Brooklyn Inland Wetlands Commission Regular Meeting Agenda Tuesday, March 12, 2024 Zoom and In-Person Meeting Clifford B. Green Memorial Center 69 South Main Street 6:00 p.m.

1. IWWC 23-015 LAC Properties, owner/applicant; Map 41 Lot 1; Providence Road, PC Zone; Proposal to fill wetlands to level site for development of a commercial building, driveways and septic system. Proposed fill equals 8,900 sf; total regulated area altered equals 64,000 sf / 1.5 acres.

The comments contained herein pertain to my review of plans (2 sheets) and supporting documentation, which is for the construction of onsite storage bins and removal of 7,700 square feet of wetland for a driveway and storage bin area. The plan was prepared by Archer Surveying, dated November 29, 2023, with revision date of January 30, 2024, for LAC Properties, LLC.

Sheet 1 of 2 – Site Development Plan

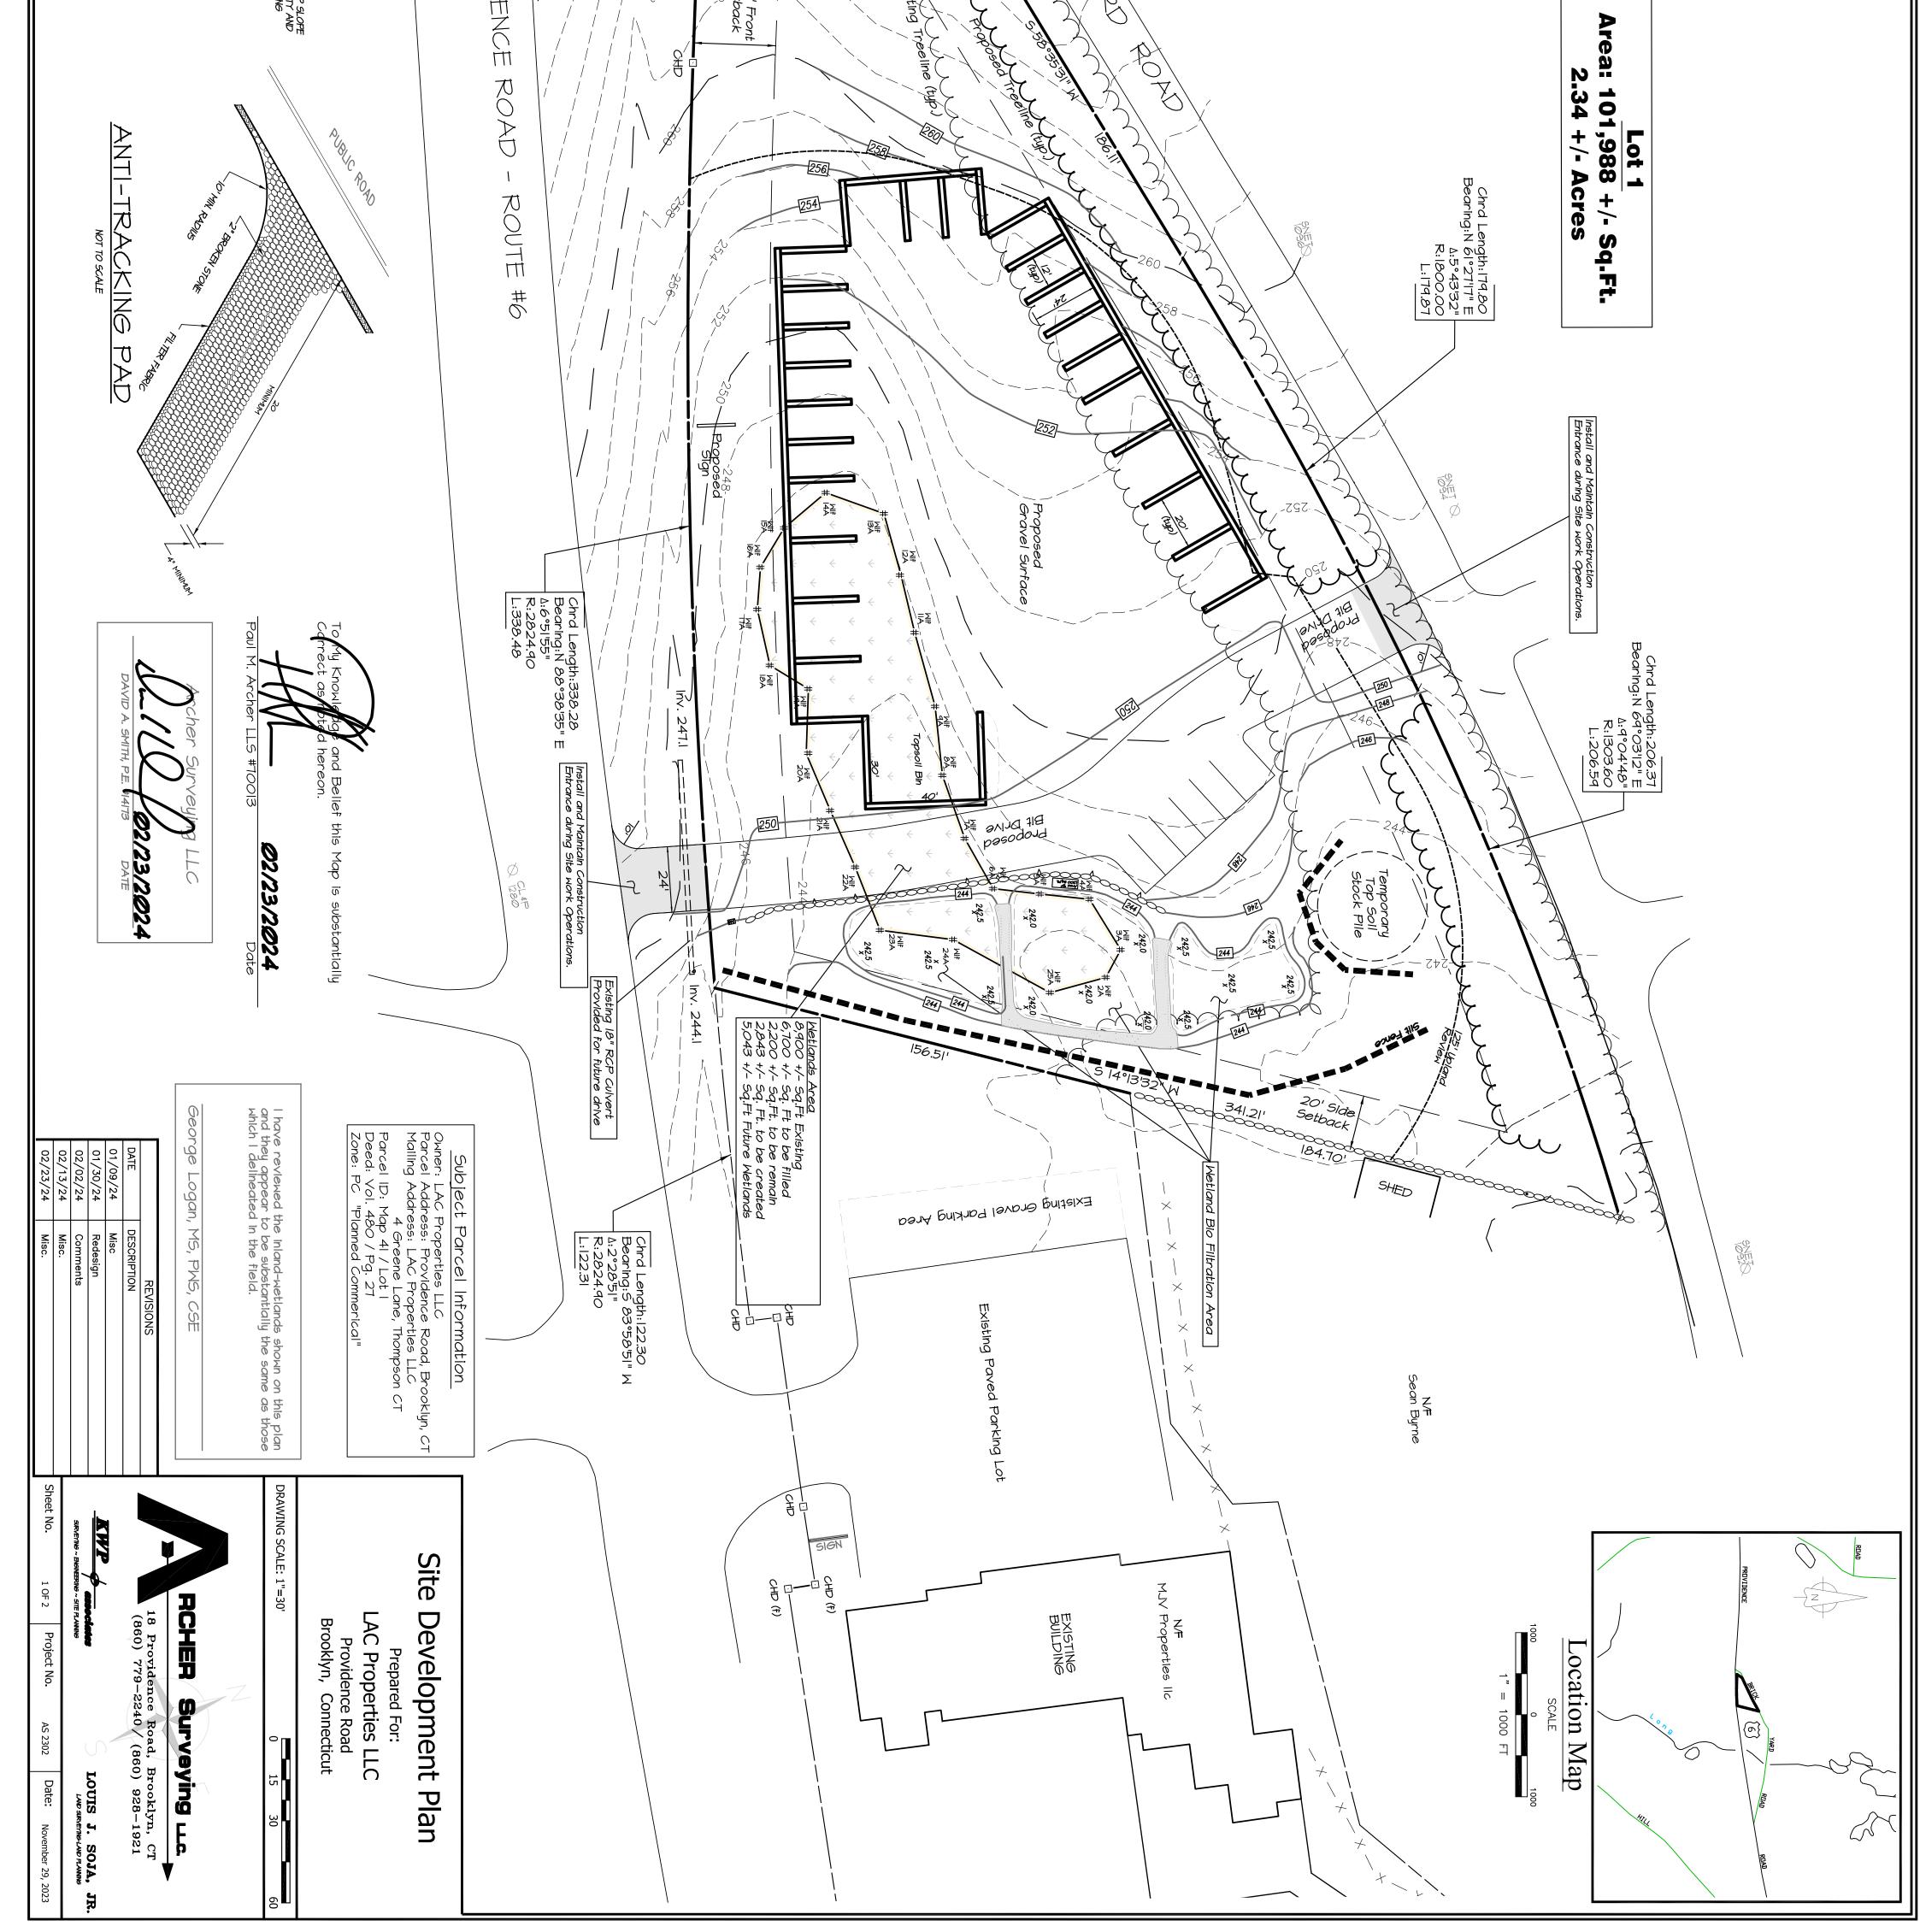
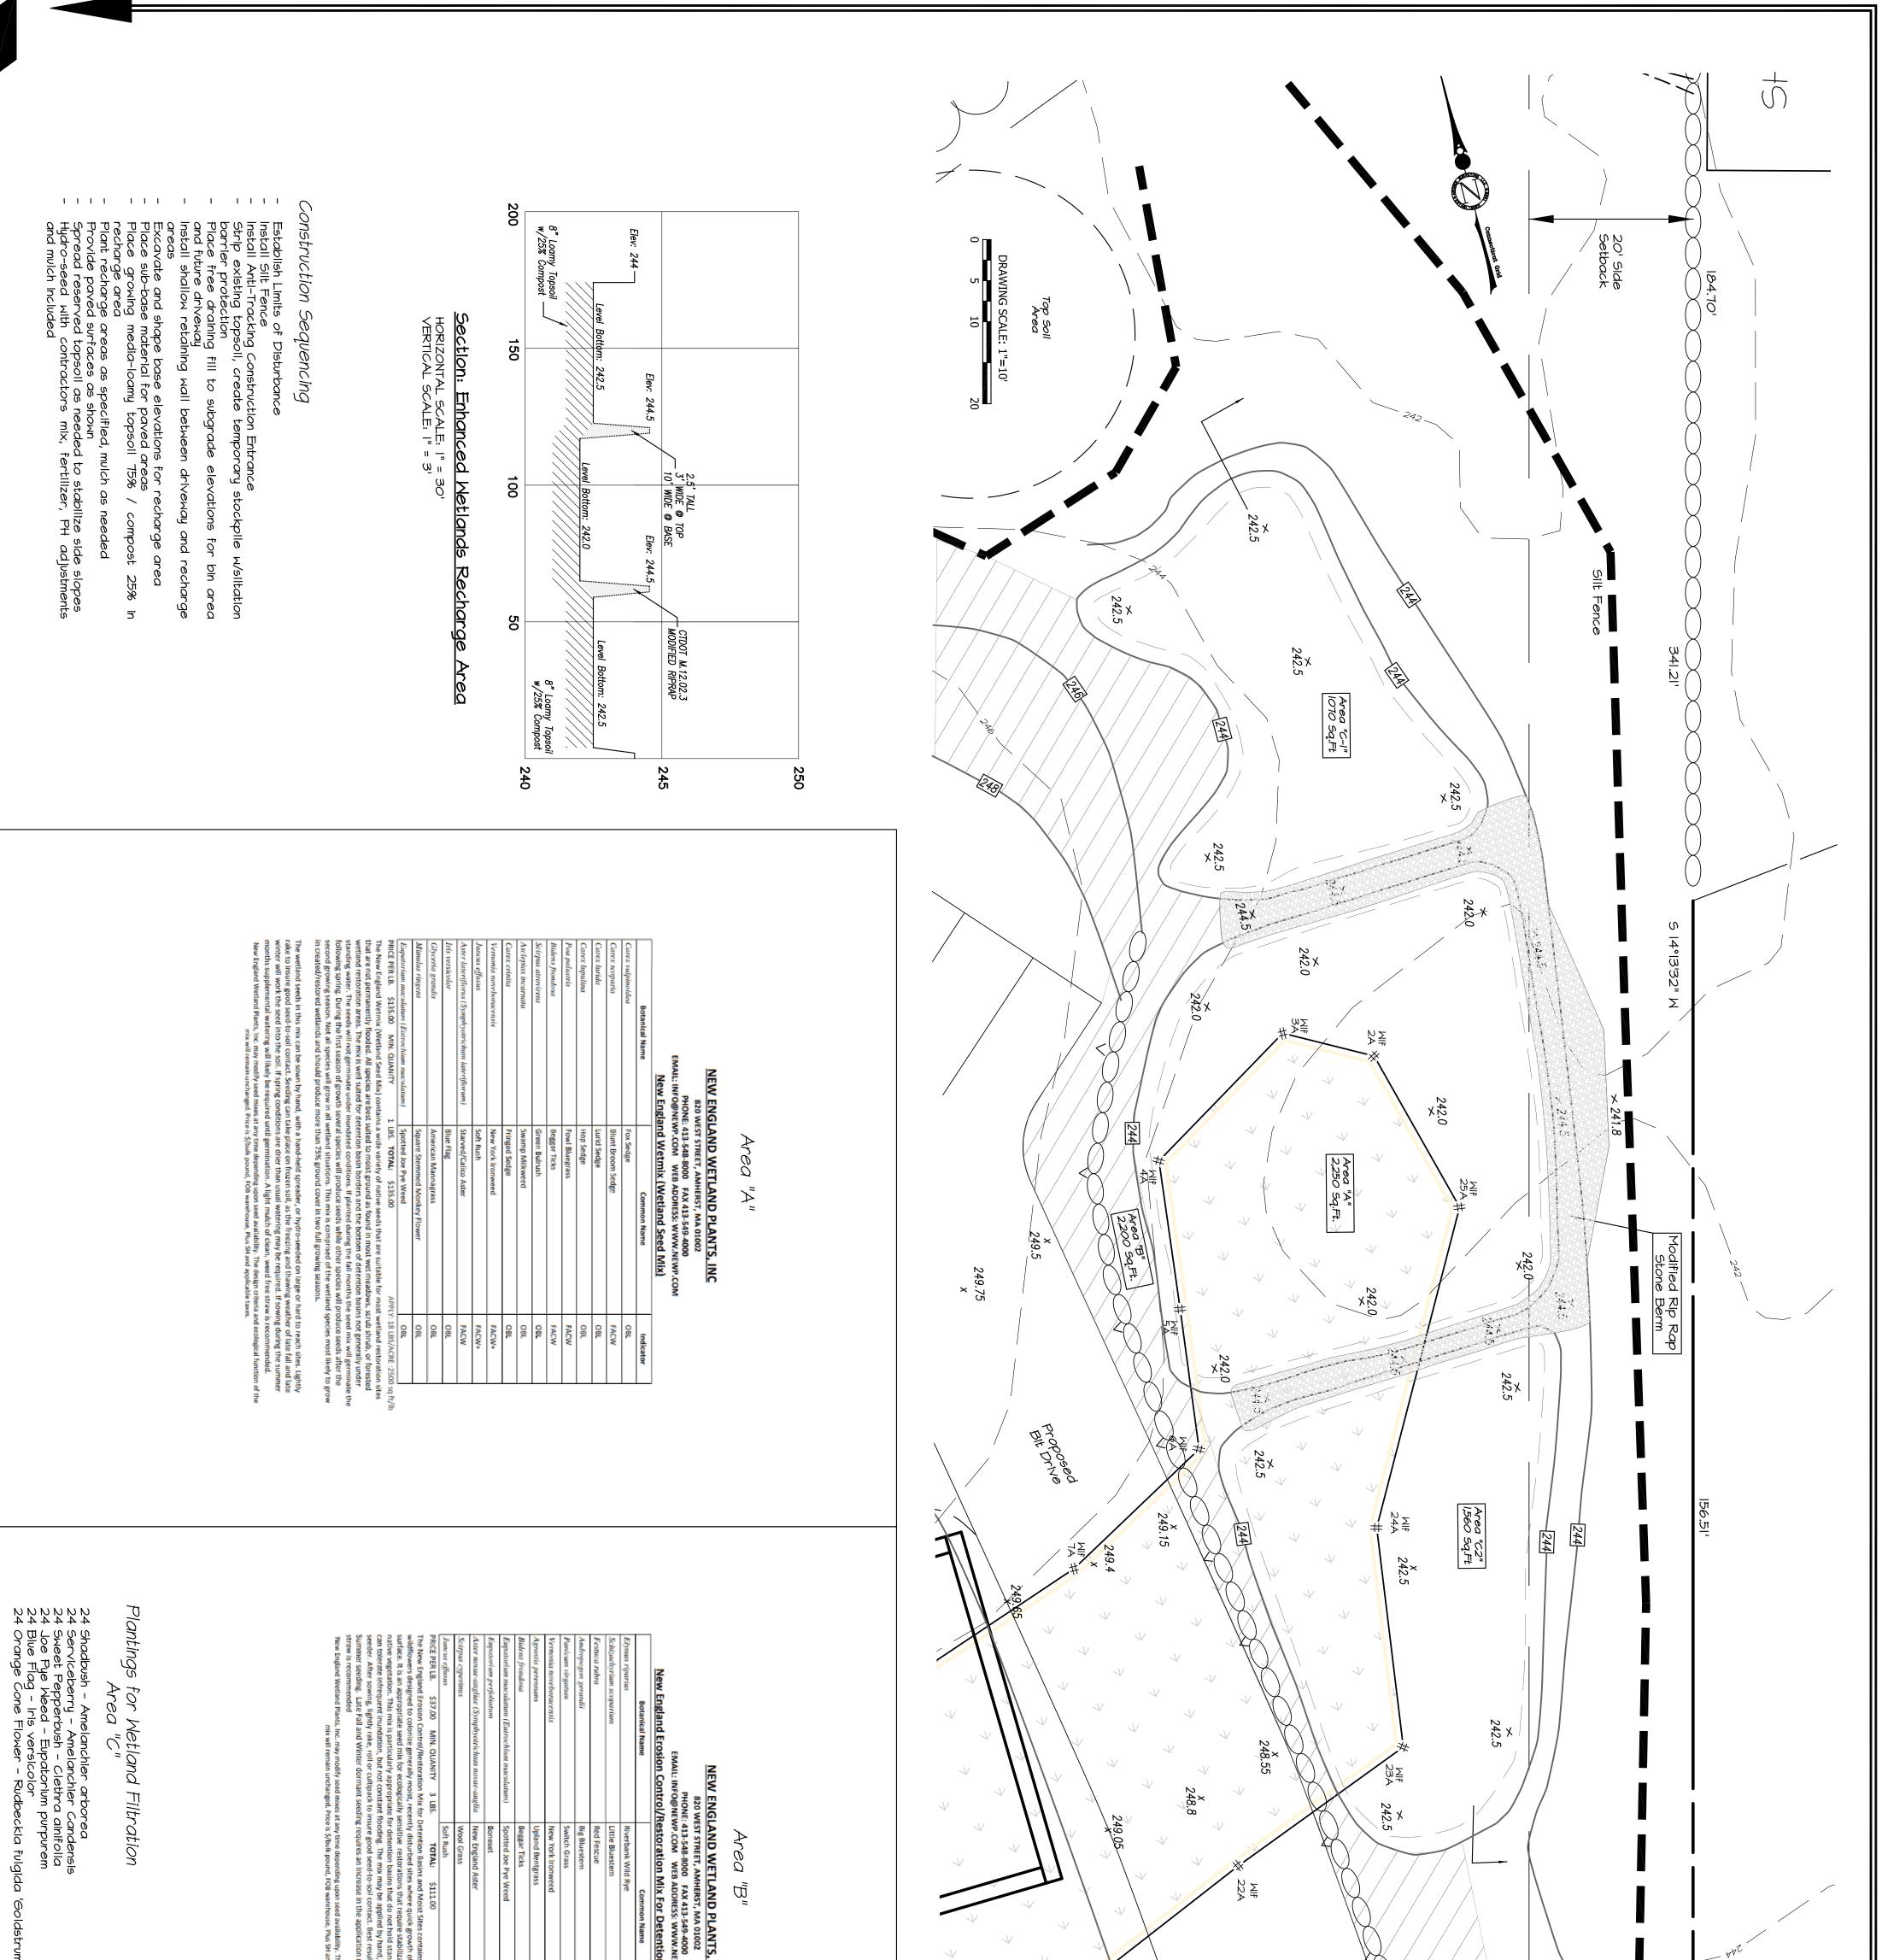
- If large construction type equipment is to be parked overnight on the property an adequate number of parking spaces need to be added to the plan to accommodate them. Where will commercial heavy vehicles park, e.g. 10-wheel dump trucks, tri-axles, etc.? Equipment can be parked in front of Bins As submitted, the plan only shows parking spaces deep enough for automobiles and pickup trucks. For Staff & Customer Parking

- Additional plantings are needed along Brickyard Road where the existing natural buffer will be reduced and also along the side property line of the Byrne property. This is to compensate for removal of low bush varieties that currently provide a visual and aural buffer to residential properties abutting the proposed development. Additionally, a landscape buffer is needed along Route 6 to screen the view of the bays and materials that will be stockpiled there. Keeping existing tree line along Brickyard Road between bins and road

- 6. How will on-site employees and surrounding neighbors be protected from dust that is generated from dumping landscape materials and the vehicles operating on unpaved earth product surfaces?Paved driveway and parking, gravel surfaced central area, Existing trees, grass areas and wetland plantings surrounding the active area.

- 7. A detail for construction of a typical bay needs to be included in the plan showing components to construct it, maximum height, etc. Bins will be precast units set on prepared base and stacked as per manufacturers design.

- 9. The "Paved Driveway Detail" shows 2" bituminous concrete for a wearing surface. This is insufficient for heavy construction equipment and the thickness needs to be increased to resist tearing, rutting, cracking, etc. that can be caused by such vehicles. Special precautions must be exercised where the driveway will be constructed over wetland soils, if it is actually built there. detail revised

- 10. Where will a business sign be located and will it be illuminated? Shown on Plan not illuminated

- 11. In the Overview section of the "Proposed Storm Water Management Plan," it is stated that there are two (2) rain gardens in the proposed development; however, there are no rain gardens noted on the plan. Where are they located? report has been revised

- 12. The "Wetland Area" note is confusing. The impacted wetland area needs to be delineated with a cross-hatch symbol and, additionally, the note be made more precise on what it is supposed to communicate. Furthermore, the "expanded wetland" area needs to be delineated on the plan with a different cross-hatch symbol to establish its location. Shown on Plan

- 13. The area of the wetland needs to have the flagging shown on the plan in place on the site for any site visit that may be scheduled. Shown on Plan

- 14. The "Wetland Bio Filtration Area" needs to be labeled properly with the aggregate area and storage volume added to the plan. Shown on Plan
- 15. Each "Rain Garden" needs to be labeled on the plan along with the bottom areas. No Rain Garden

- 16. A portion of the "Modified Rip Rap Stone Berm" and two of the storm water management basins are shown constructed within the 20' side yard setback. This portion of the berm and basins need to be moved out of the setback area since they are a permanent structure no different than the walls of a cement block bin having to be outside of a setback area. The setback line in this area needs to be identified in the field during construction with multiple stakes to avoid intrusion into it. Not a Structure

- Access to the property should be restricted to the Brickyard Road entrance to eliminate the danger of a vehicular accident involving heavy vehicles slowing down and stopping to enter this property from Providence Road (Route 6). Commercial Building in the Planned Commercial District should be entering & exiting from State Highway

- 18. Will the entrance to the property be gated? If so, the gate needs to be added to the plan. No Gate
- 19. CT DOT District 2 will need to review this plan for the entrance/exit onto Route 6. Has this been submitted for their review and approval? Plans will be sent to DOT, driveway entrance exsits

- 20. The professional engineer's and land surveyor's seals need to be affixed to the plan. Done

- 1. The "Rain Gardens" and "Wetland Bio Filtration Area" need to be labeled properly on this plan and the bottom area noted, to avoid confusion. As presented, the entire area is mistakenly labeled as the filtration area. Done

- 2. A detail is needed for the "Modified Rip Rap Stone Berm" to see how it is to be constructed. Additional details have been provided, location is approximate and will be 'field fit' at the time of construction.

- 3. If the "Berm" is constructed without a solid high impermeability core, how will the adjacent property to the east be impacted from the concentrated overflow of ponded water? Side Basin will flow into center basin, center basin to existing discharge point. No change to flow path is anticipated

- 4. The section lines in the plan view of the storm water collection areas need to be labeled more precisely to key into the "Section: Enhanced Wetlands Recharge Area" at the bottom of the sheet,

- e.g., Section A A. Details provided, section lines not necessary
- 5. The professional engineer's seal needs to be affixed to the plan. Done
